10.3 Main Steam Supply System

The information in this subsection of the reference ABWR DCD, including all subsections, tables, and figures, is incorporated by reference with the following departures and supplements.

Figure 10.3-1 Main Steam Supply System

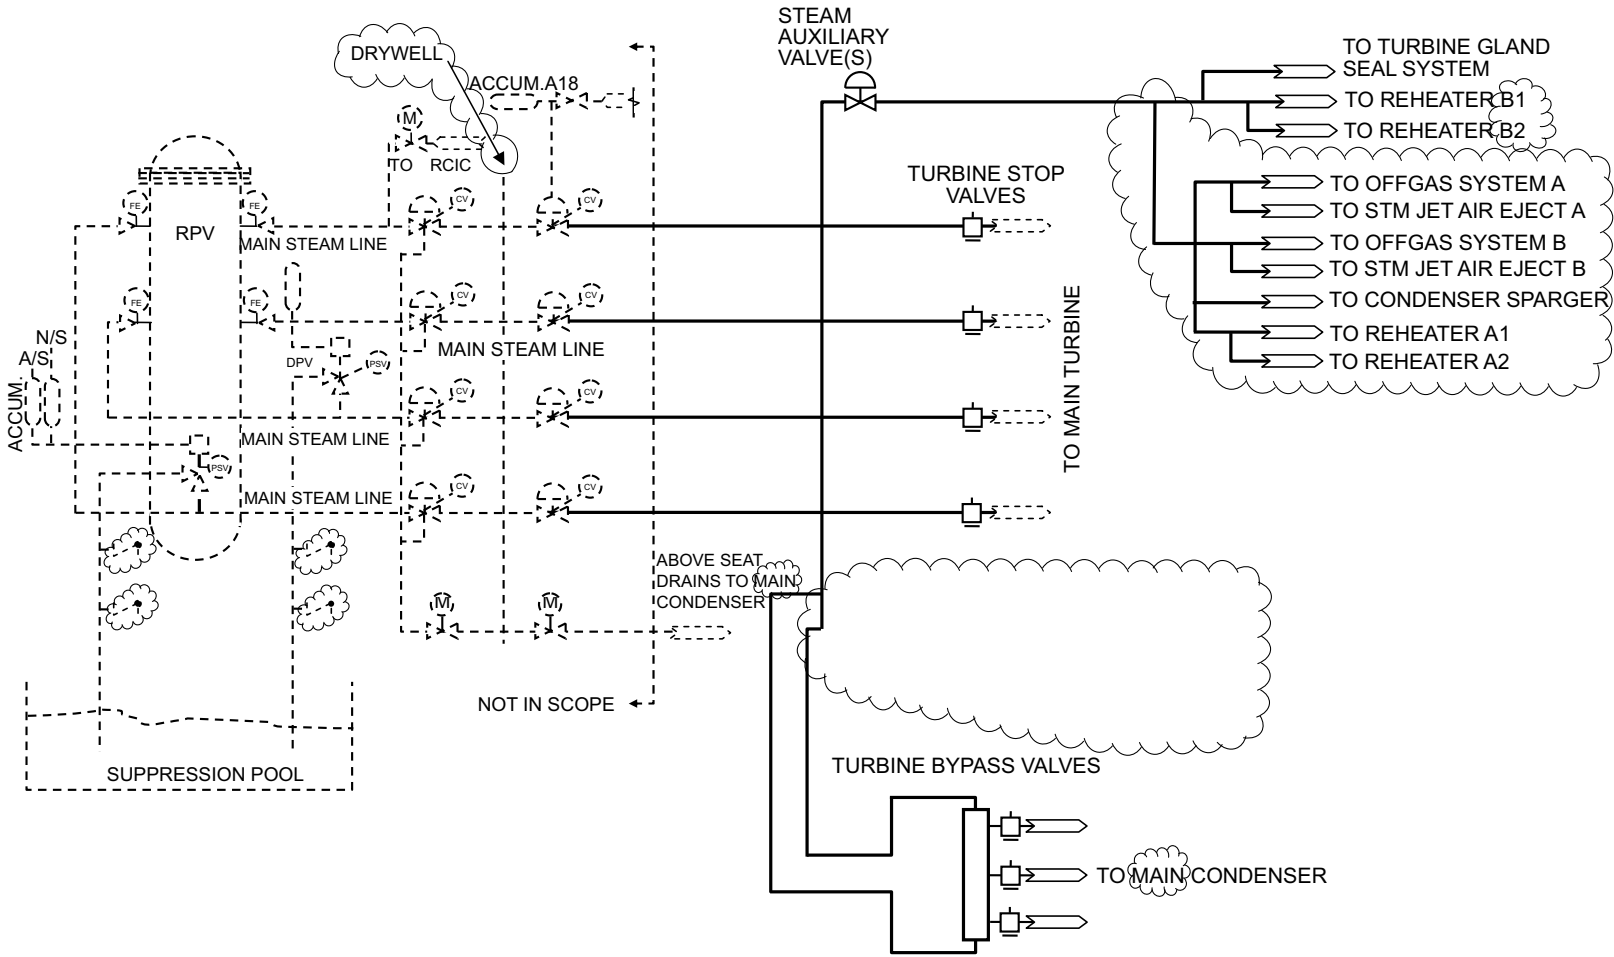
STP DEP 10.2-1 (Table 10.3-1, Figures 10.3-1 and 10.3-2)

Figure 10.3-2 Main Steam Turbine System

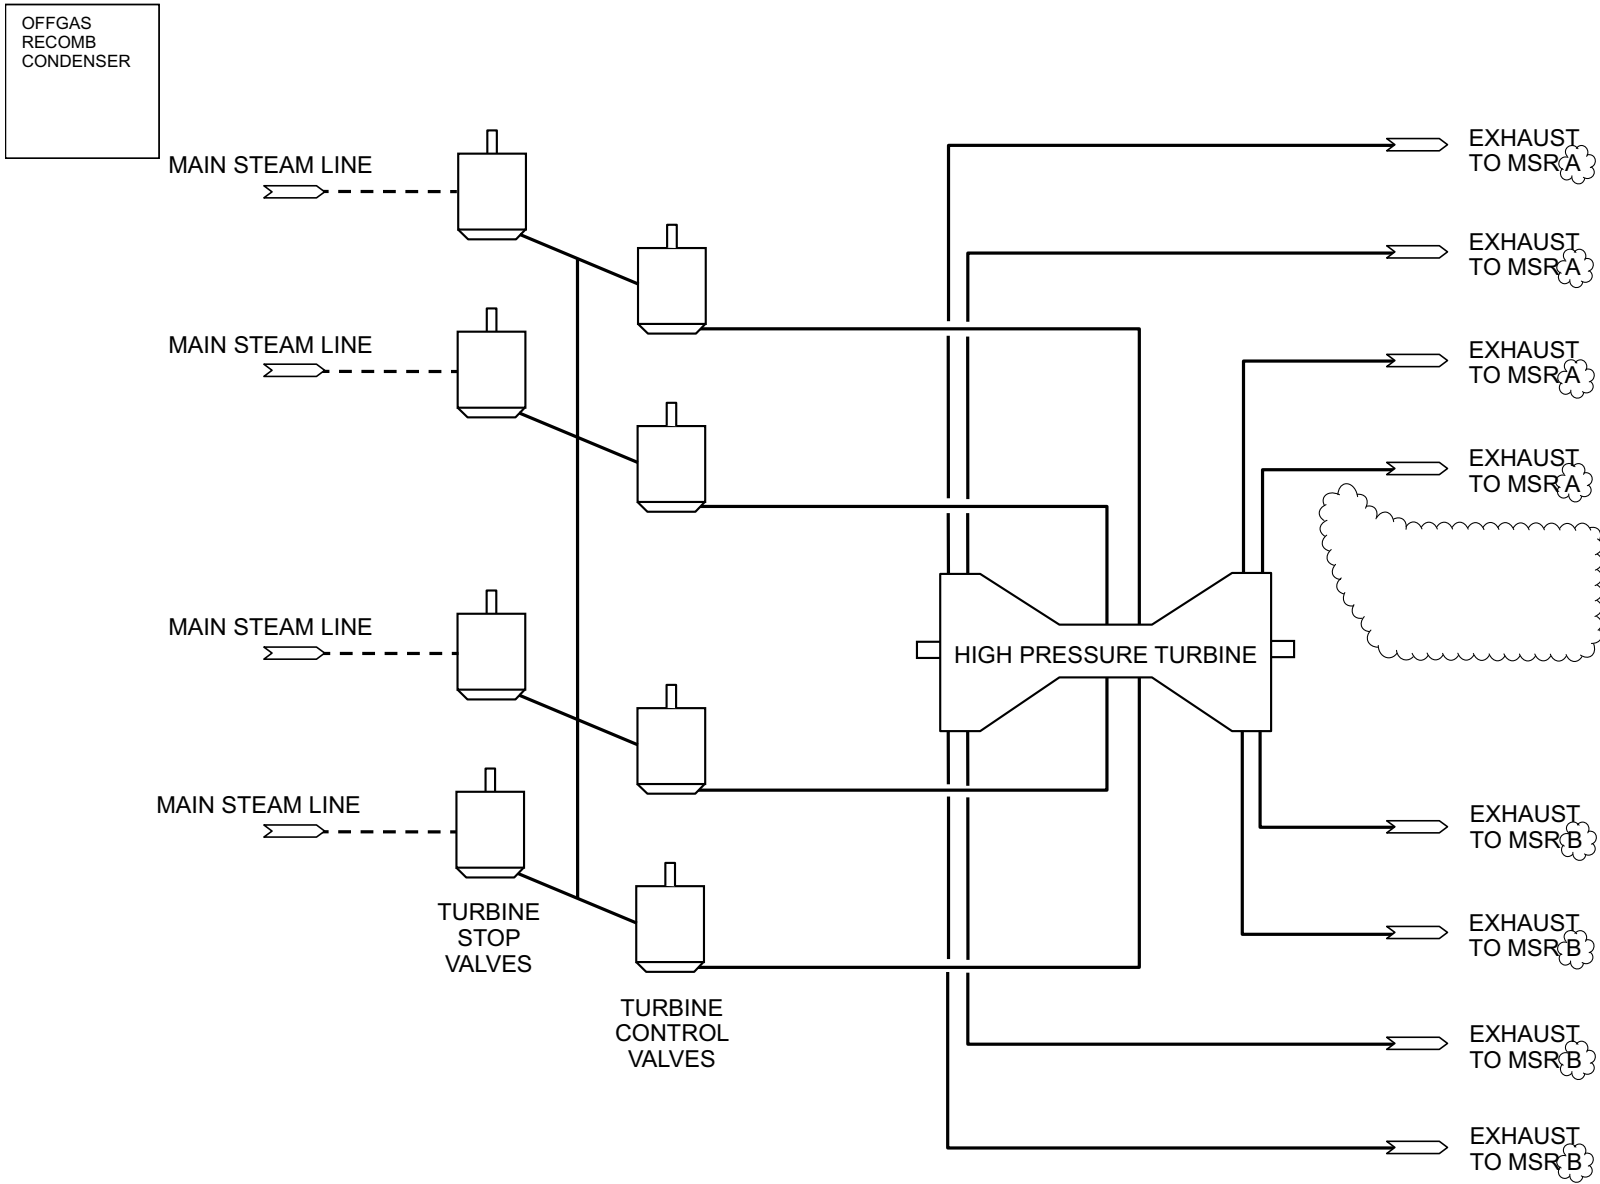
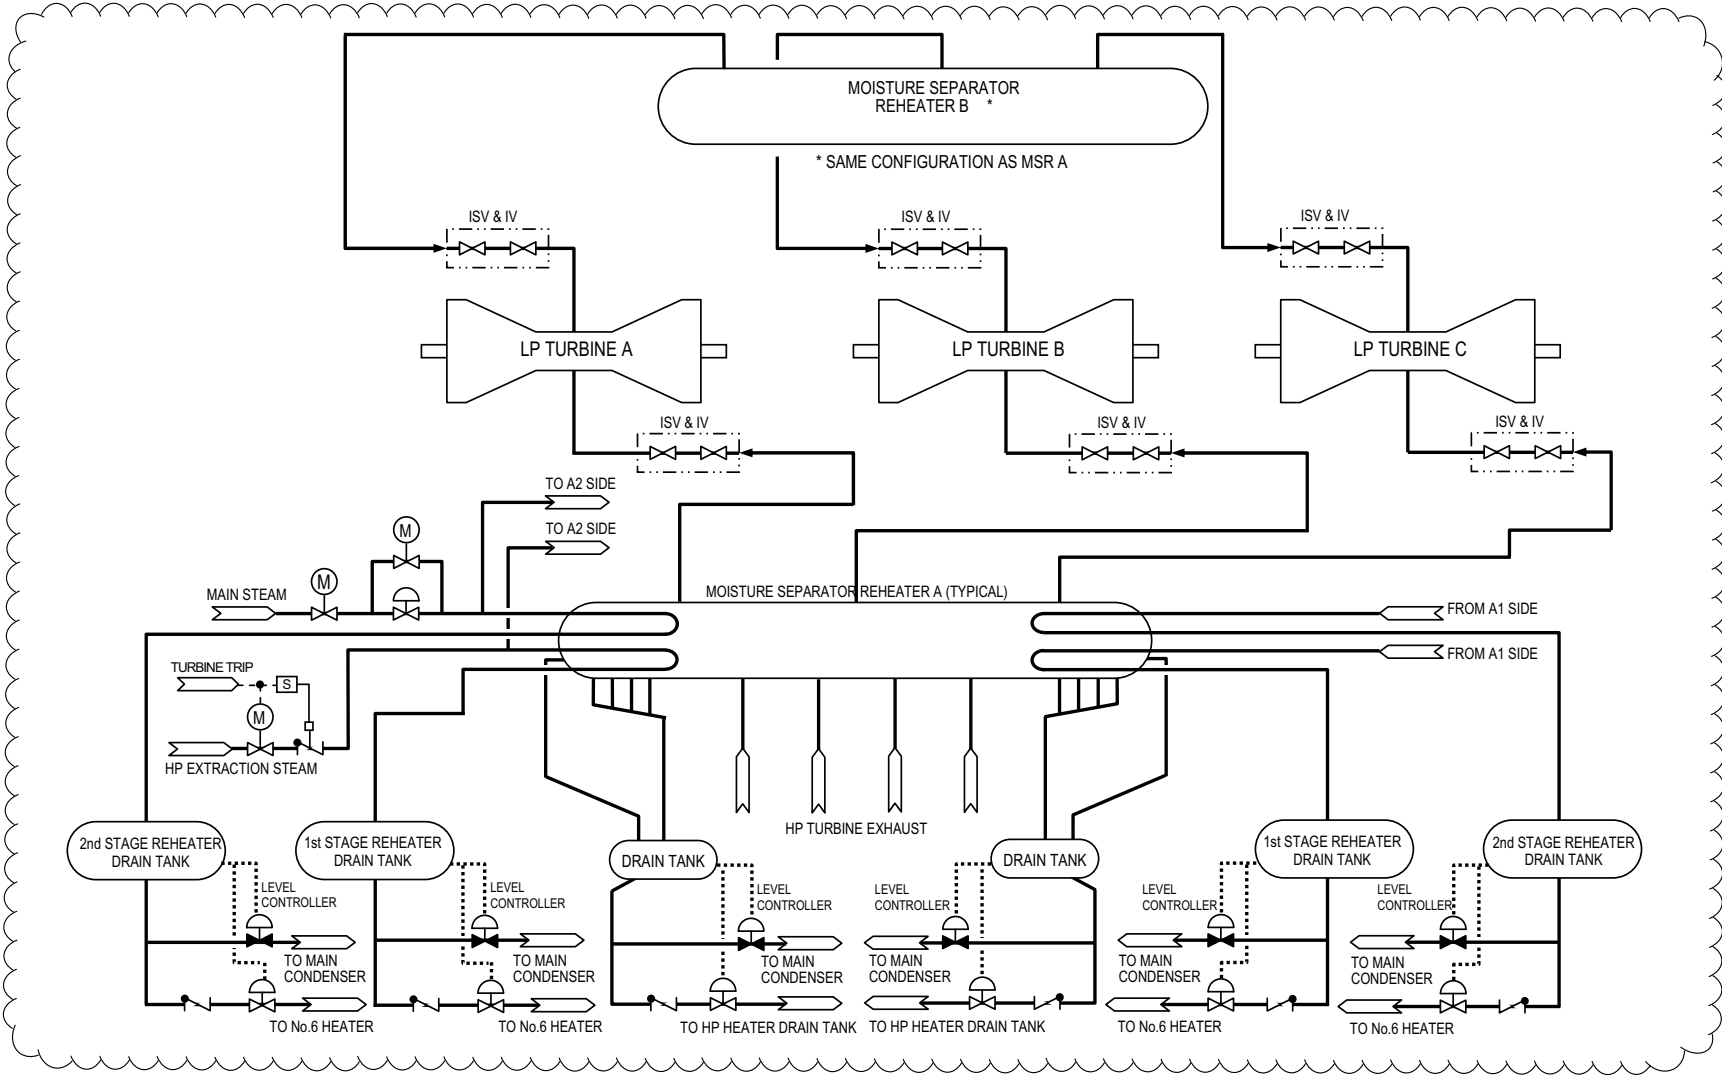
STP DEP 10.4-3 (Figure 10.3-2)
